Product Change Notice

DESCRIPTION OF CHANGE:
The Eaton PowerStor XB and XV Series supercapacitors are receiving a visible change. This change involves adding a groove around the circumference at the center of the length, as shown in the illustration below.

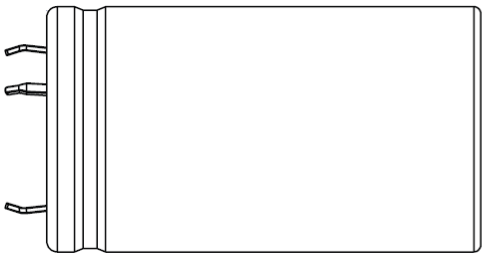
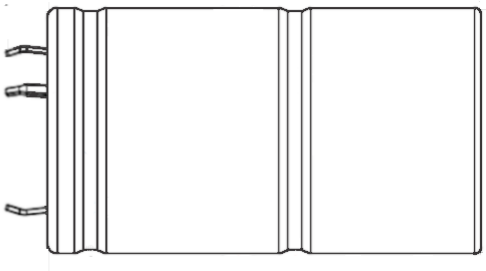
REASON FOR CHANGE:
This groove enhances mechanical stability to the electrode structure inside the can and is part of our continuous improvement efforts.

EXPECTED INFLUENCE ON QUALITY, RELIABILITY, PERFORMANCE:
There is no change to the form, fit, electrical properties, or function of these supercapacitors.
